**Public Input No. 3085, Assigned to Code-Making  
Panel 1, Refer to Code-Making Panels 2 - 18**

**Public Input No. 3085-NFPA 70-2023 [ Global Input ]**

**This Global Public Input is for all Technical Committees and review their informational notes and the requirements in the NEC Style Manual Section 2.1.10 for informational notes.**

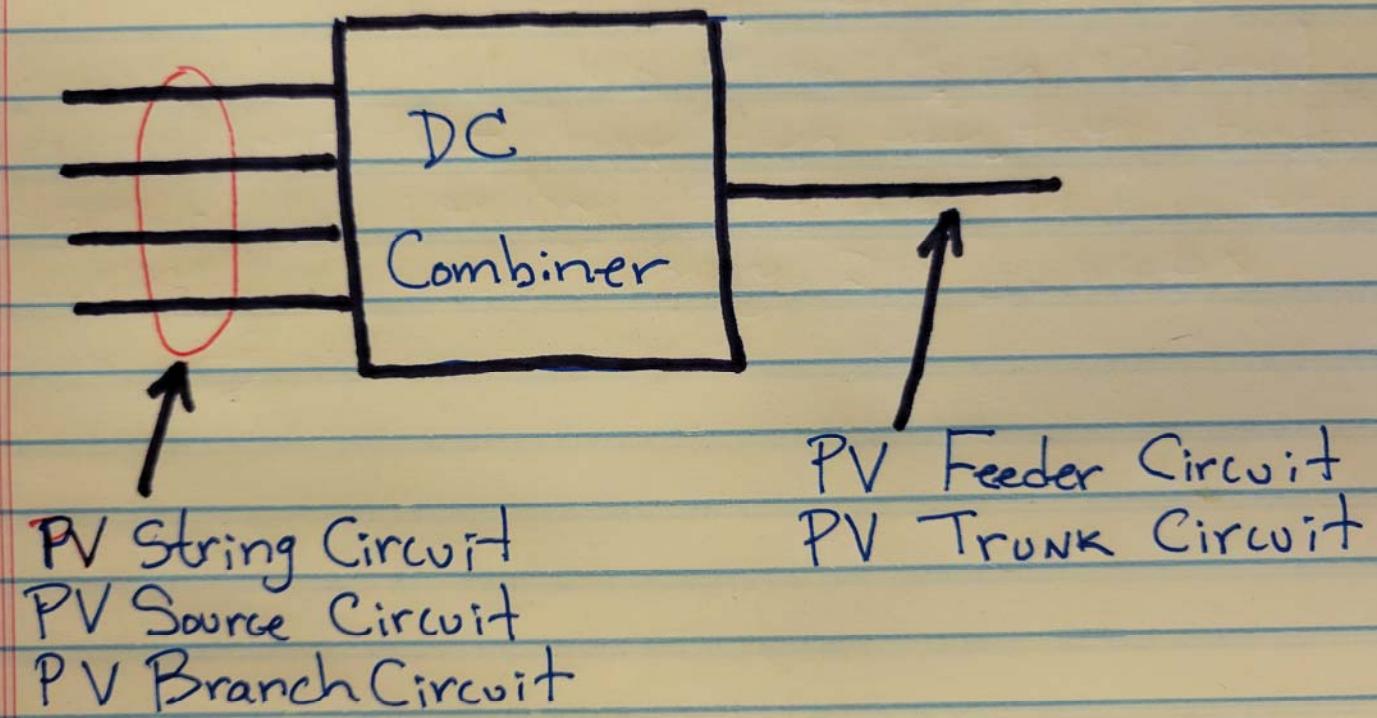
For the combiner output side ELIMINATE the repetitive term SOURCE and consider using FEEDER or TRUNK.

The lower current INPUT and the combined higher ampacity OUTPUT conductors from the combiner box should be distinctly annotated to clarify the direction of power flow in the system
